This Service Letter reidentified as
Service Bulletin M 20-127
per Service Instruction M20-15.

SUBJECT: Inspection of Hartzell Propellers and Installation
of Mooney Decal

MODEL AFFECTED: M20E, S/N 101 - 722

FIGURE # 1

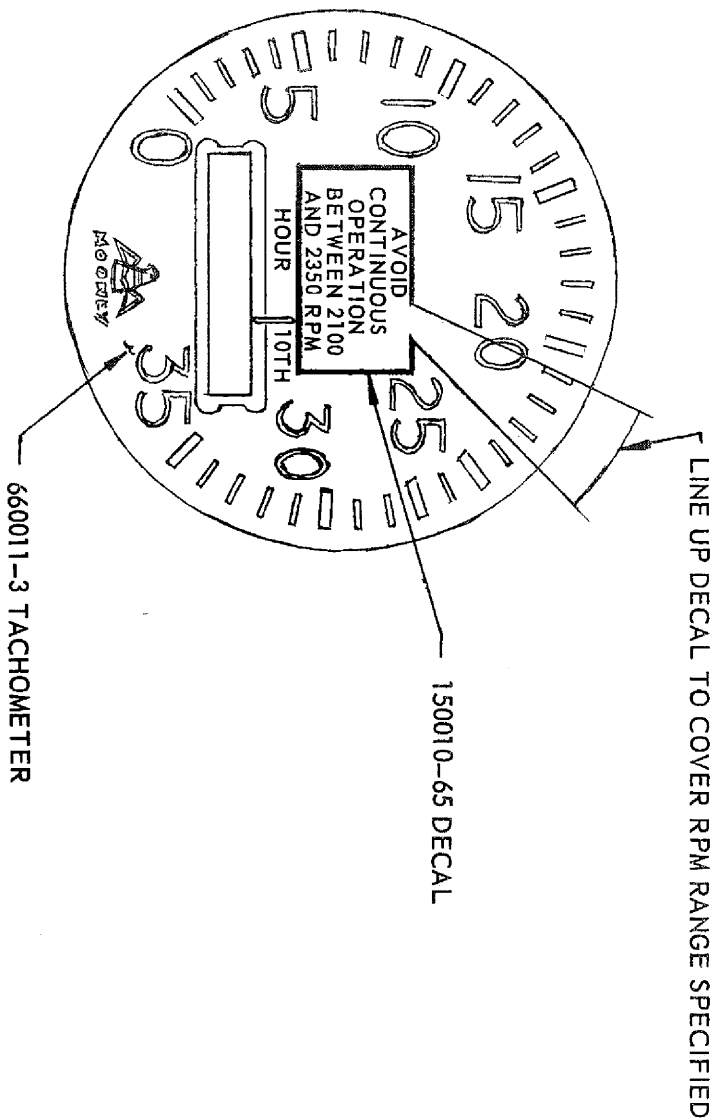
- INSTRUCTIONS:**
1. Wash the Bezel glass with alcohol.
 2. Apply 150010-65 decal as shown in Figure 1.
 3. Inspect blades for nicks. If nicks are present, inspect blades for cracks by dye penetrant method. Replace blade or propeller if cracks are present in blade or blades. If cracks are not present in the blades, remove nicks from the propeller blade per Hartzell Bulletin No. 31.
 4. Make log book entry to show compliance with this Service Letter.
